Re: Response to Planning Comments - File Review for Project No. 13-20-0158 / Township of Langley

BC BUILDS - ALDERGROVE

FRASER HWY & 272
STREET, LANGLEY BC

Job no. 2423
Sheet no. A1.06

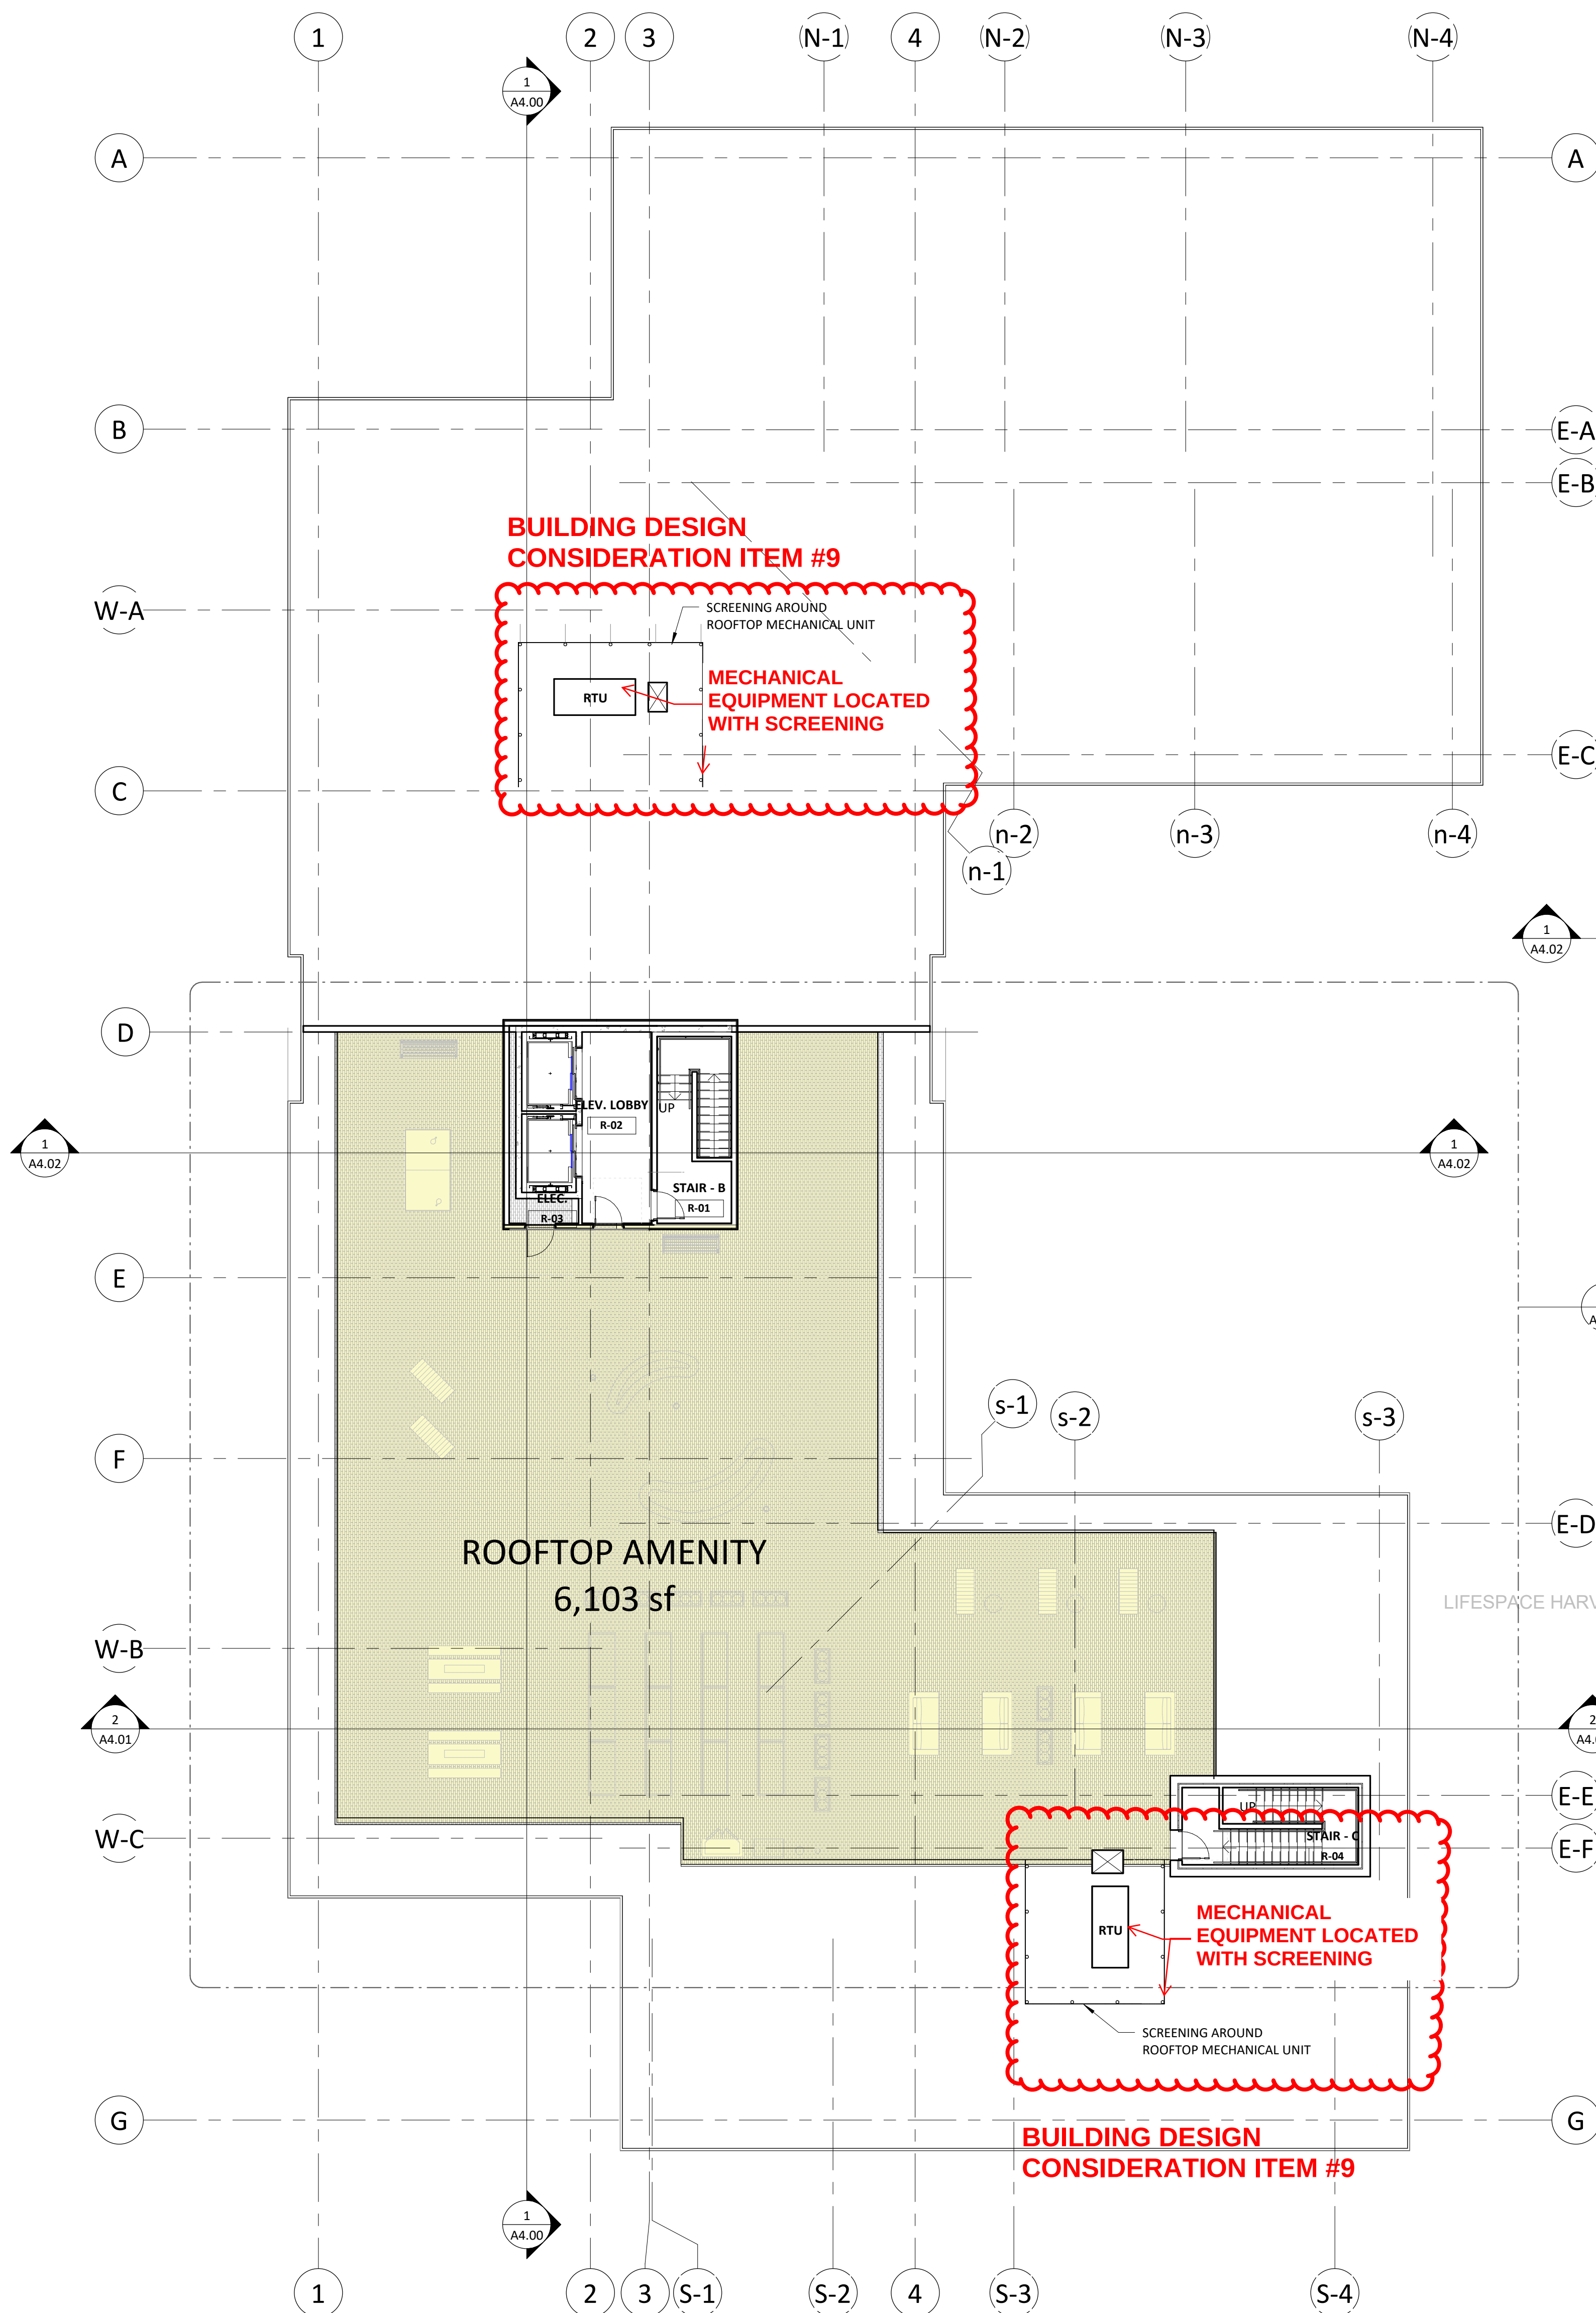
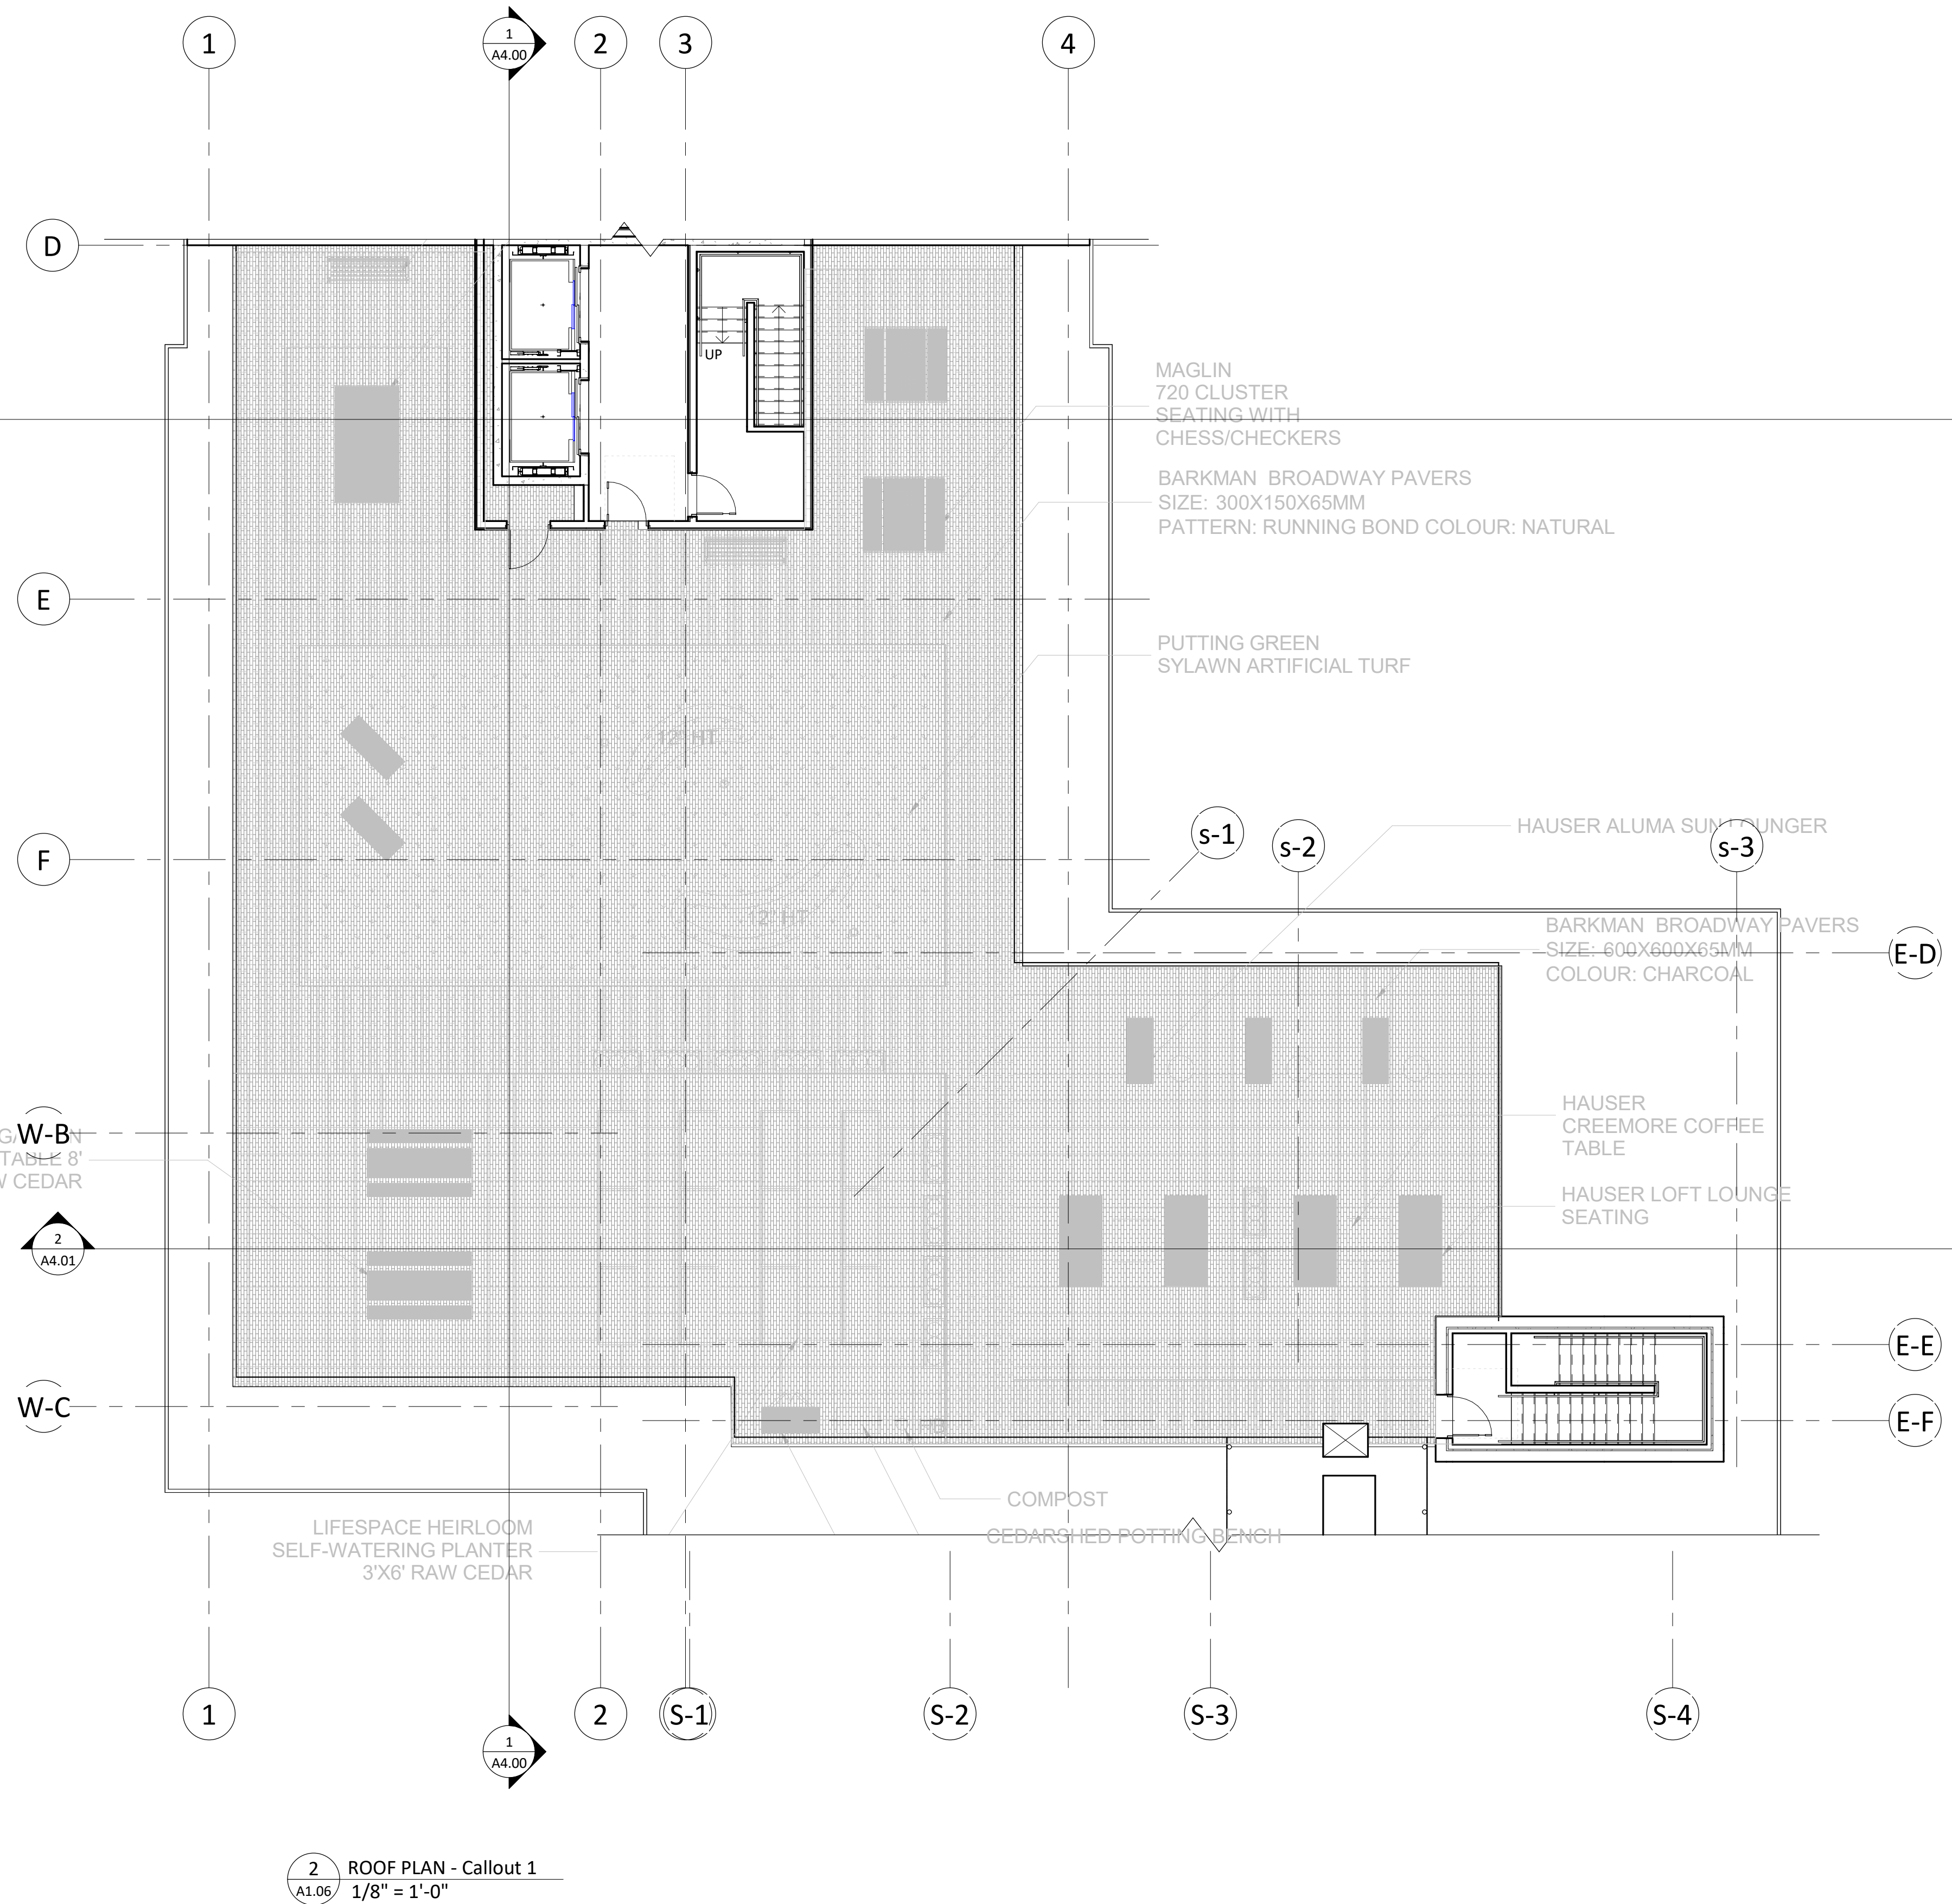
9. Please clarify if any mechanical equipment is proposed, and update drawings to reflect if there is. Staff note that mechanical equipment will require screening.

- **Mechanical equipment location is included on the updated drawing set. Equipment will be screened.**
